AMENDMENTS TO THE DRAWINGS

Attached herewith for the Examiner's approval are replacement drawing sheets which include proposed changes to FIGS. 1-3. The figures are labeled as "PRIOR ART" in accordance with the Examiner's suggestion.

CISCO-1254

FIG. 1

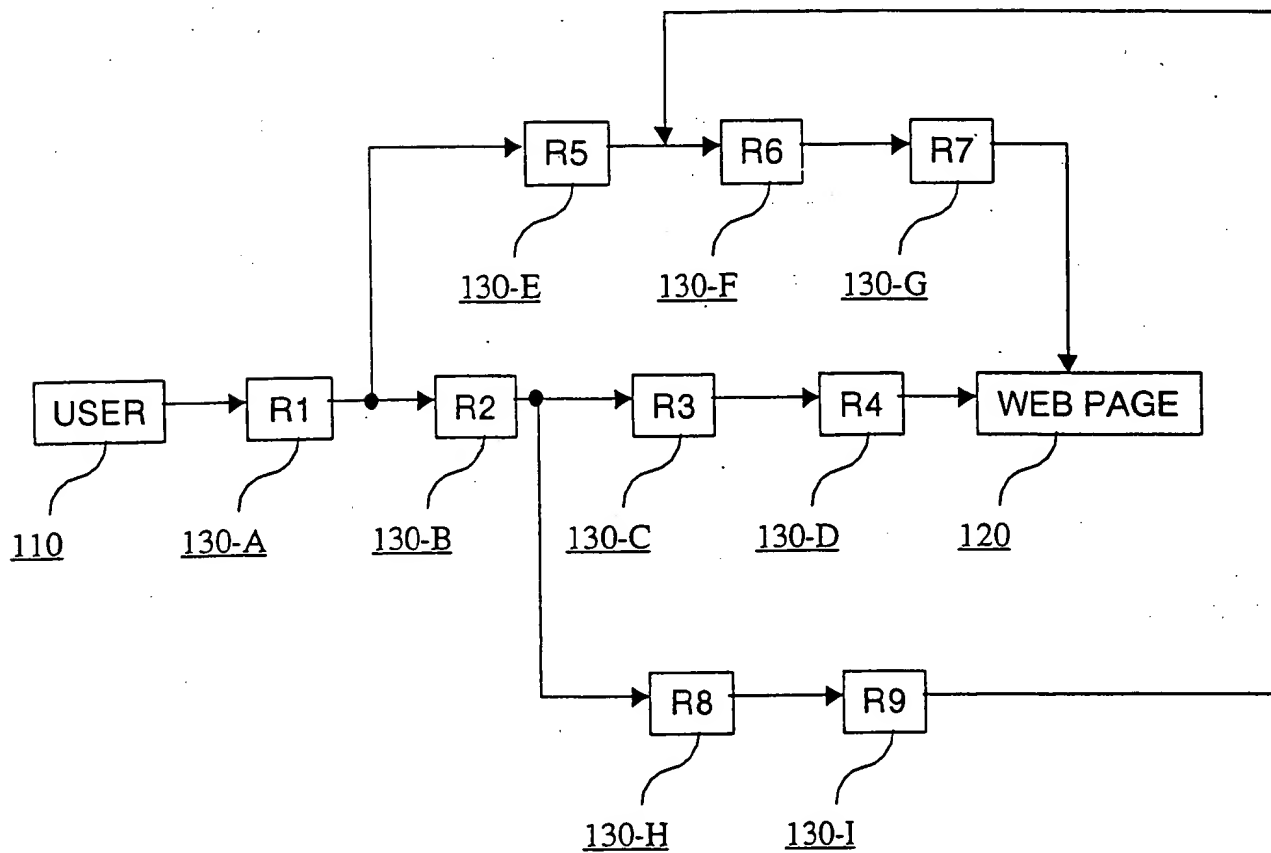
PRIOR ART

FIG. 3

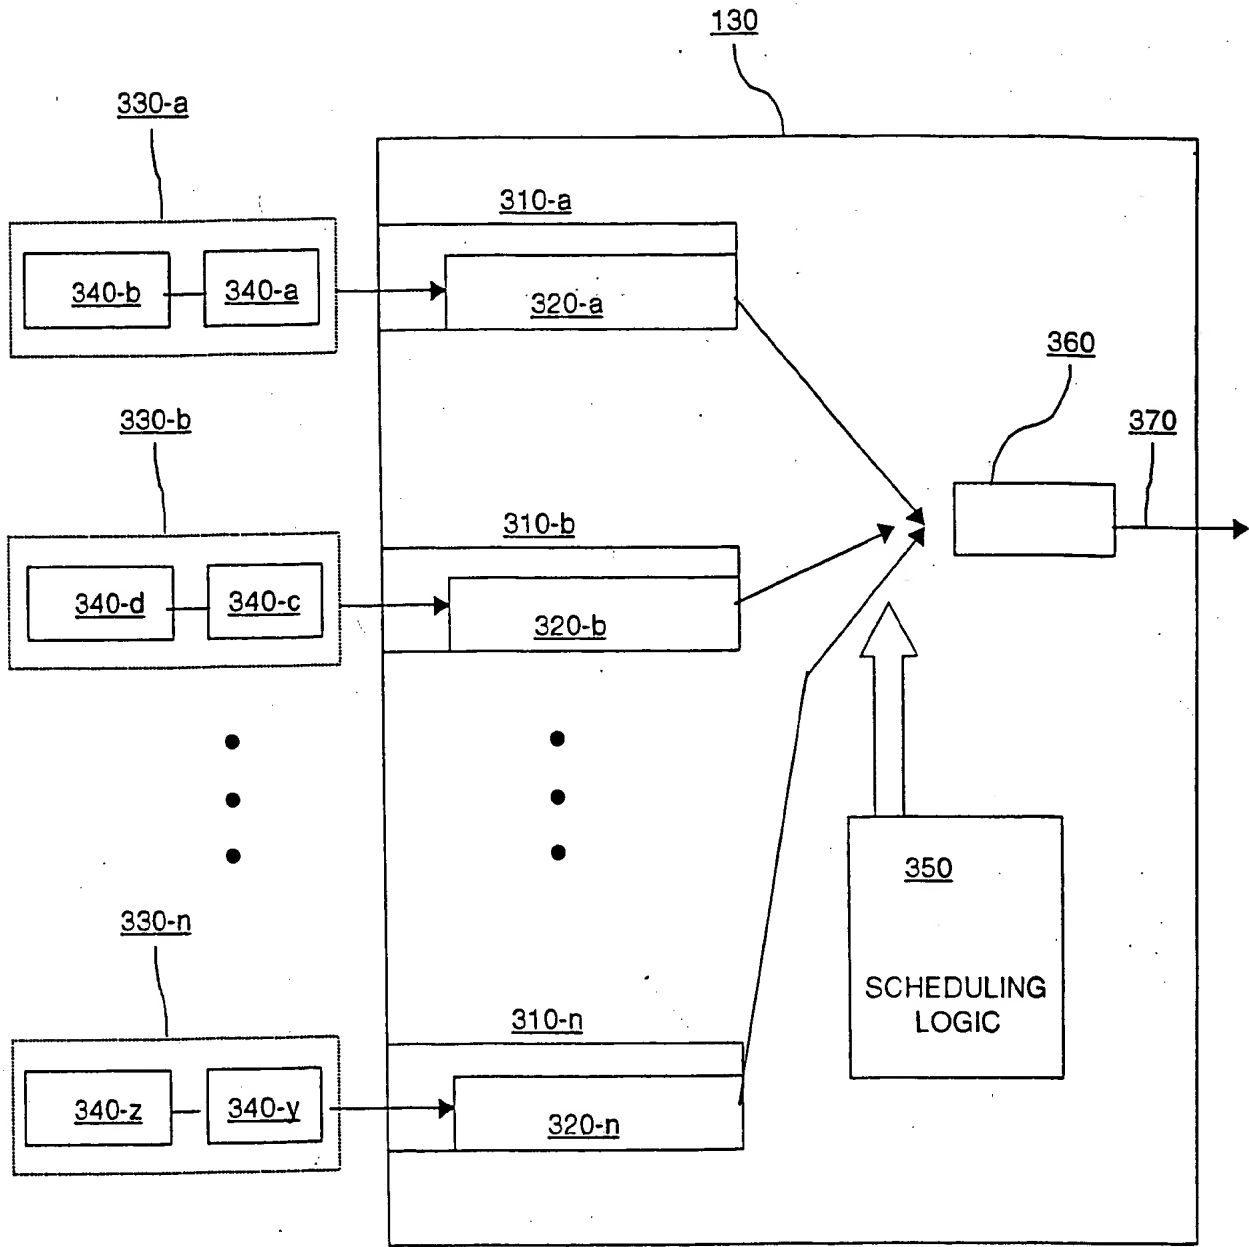
PRIOR ART
